## PLANNING COMMISSION AGENDA

**PLANNING REPORT**

SUBJECT: Afton - Nelson Estates Preliminary Plat

## EXHIBIT D - PRELIMINARY PLAT

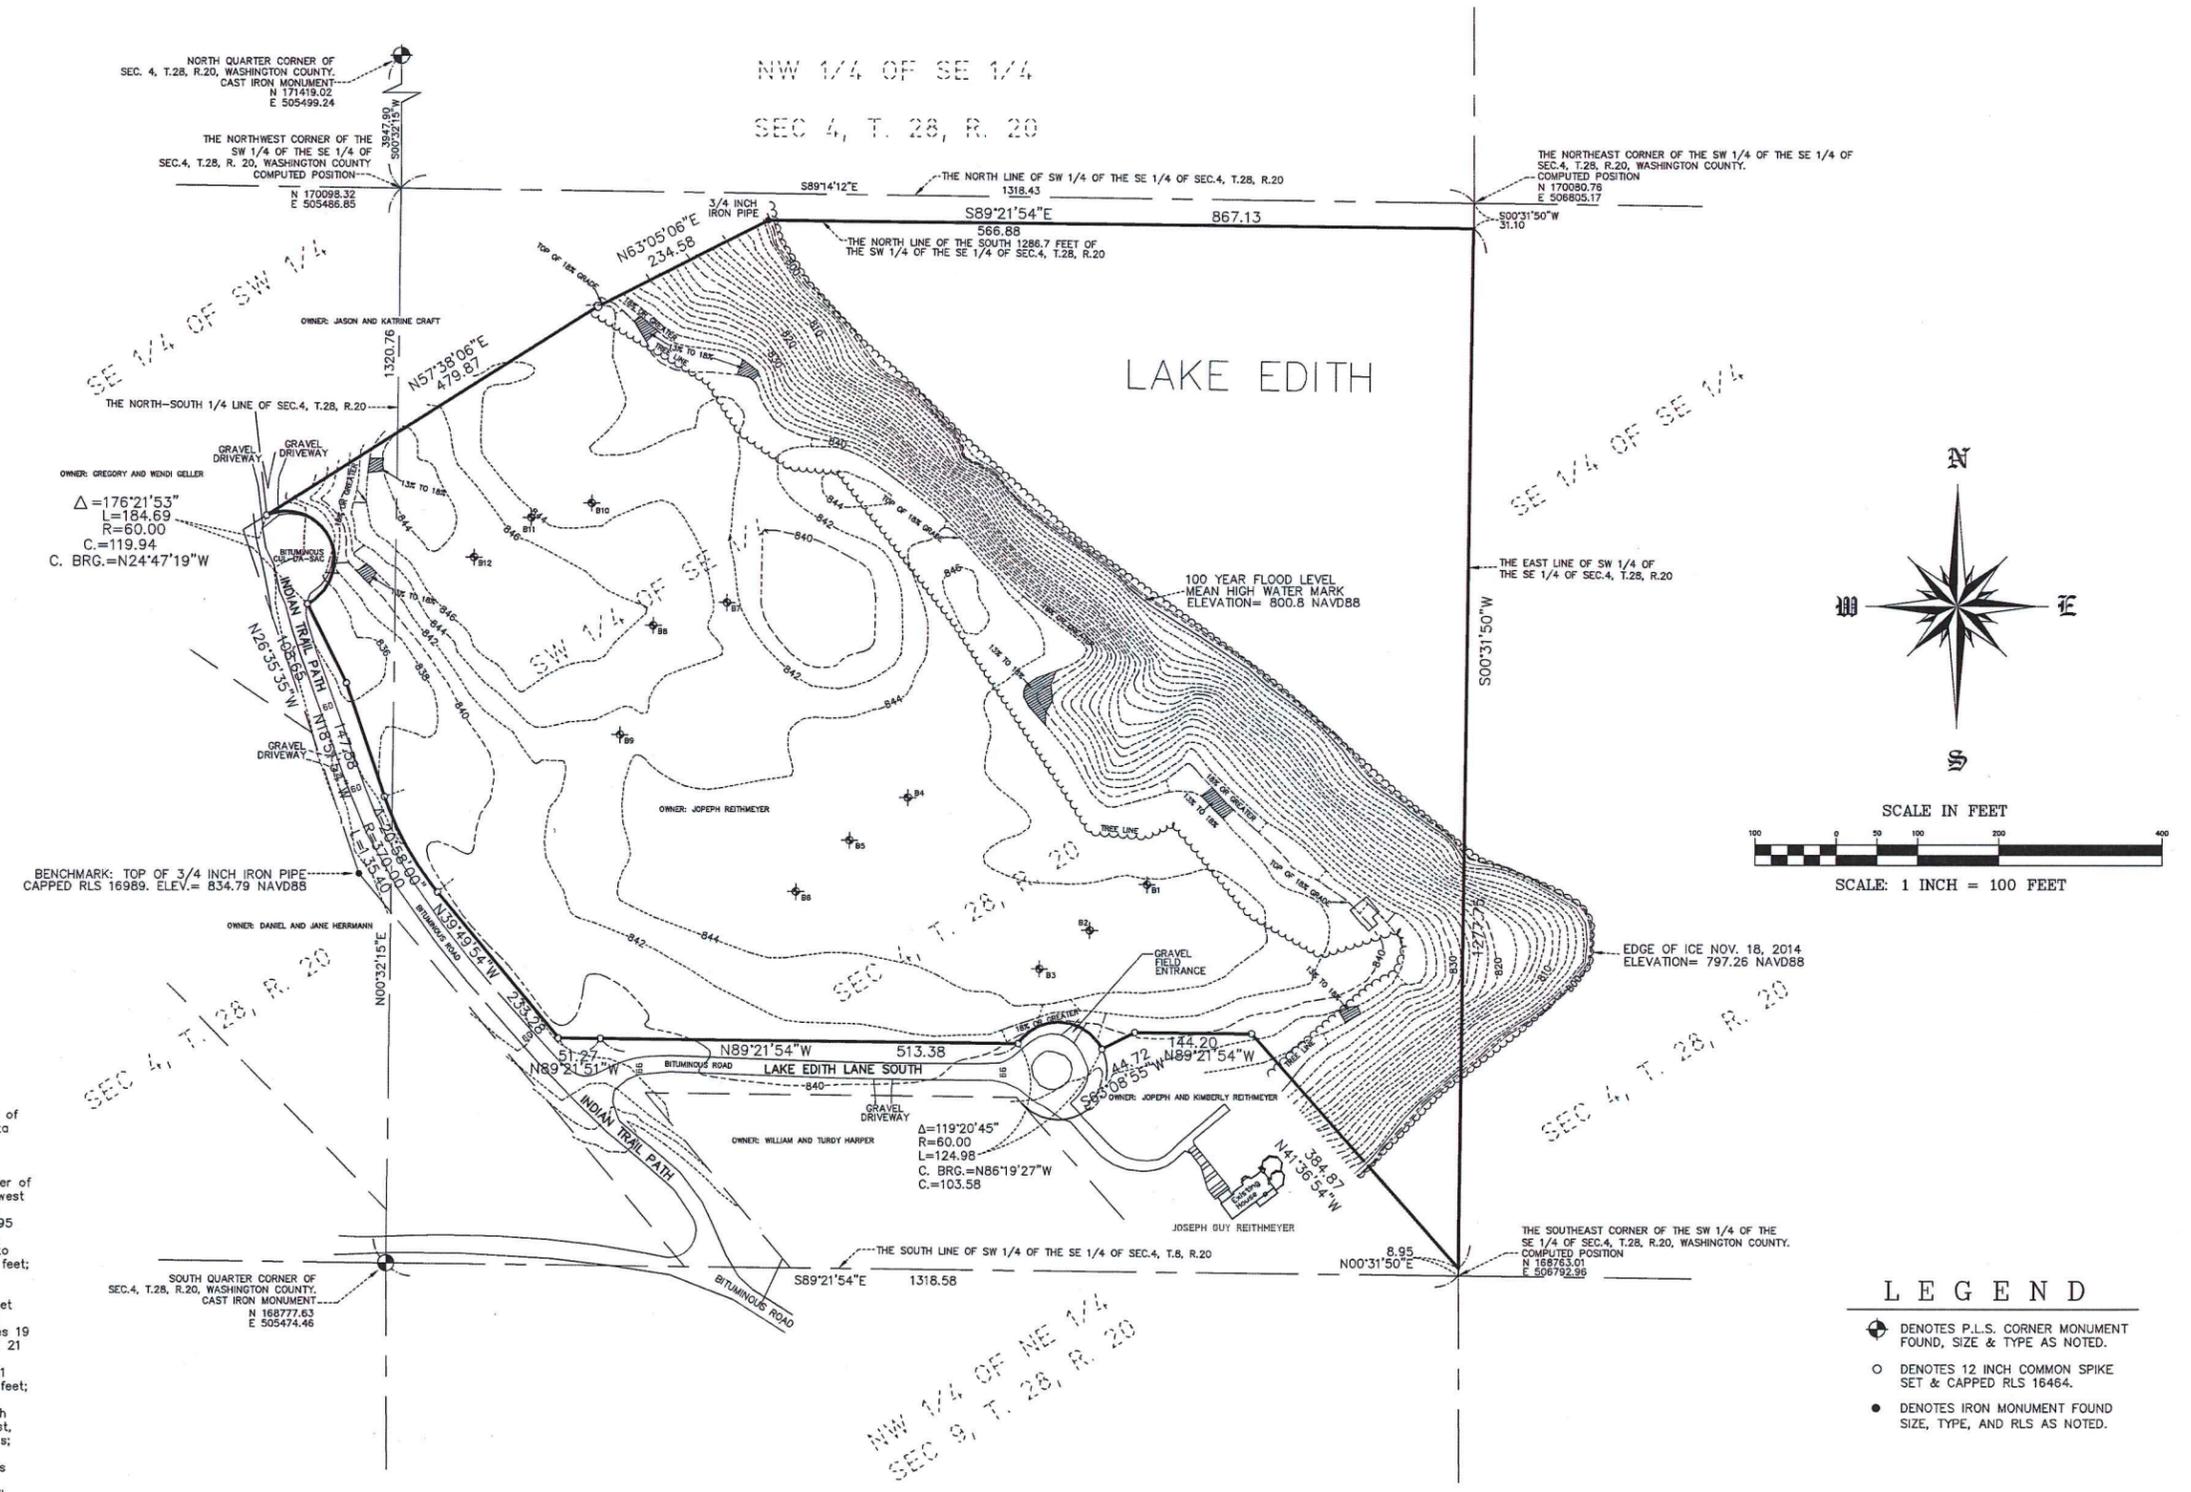
All proposed lots illustrate an ability to meet the aforementioned setbacks (via illustrated building pads).

As shown on the submitted preliminary plat, Lot 3 borders the intersection of Indian Trail Path and Lake Edith Lane. According to the Ordinance, the minimum driveway setback between intersecting streets is 60 feet. This requirement should be specifically recognized as part of Lot 3 development.

Utility Easements. In accordance with Section 12-1384.A of the Subdivision Ordinance, 20-foot-wide utility easements, centered on rear and other lot lines, are shown on the submitted preliminary plat.

As a condition of preliminary plat approval, primary and secondary septic sites must be illustrated on the preliminary plat in compliance with Section 12-413 of the Zoning Ordinance (Sewage Treatment) and Section 12-1328.C.9 of the Subdivision Ordinance (Preliminary Plat Data Requirements).

1. Both the Indian Trail Pass and Lake Edith Lane roadways shall be located within public right of-way and shall be provided 15 foot setbacks from property lines (to accommodate private utilities and snow storage). This issue shall be subject to further comment by the City Engineer.

2. The adequacy of the streets serving the property shall be subject to comment and recommendation by the City Engineer.
3. Driveway placement for Lot 3, Block 1 shall be setback a minimum of 60 feet from the intersection of Indian Trail Path and Lake Edith Lane.
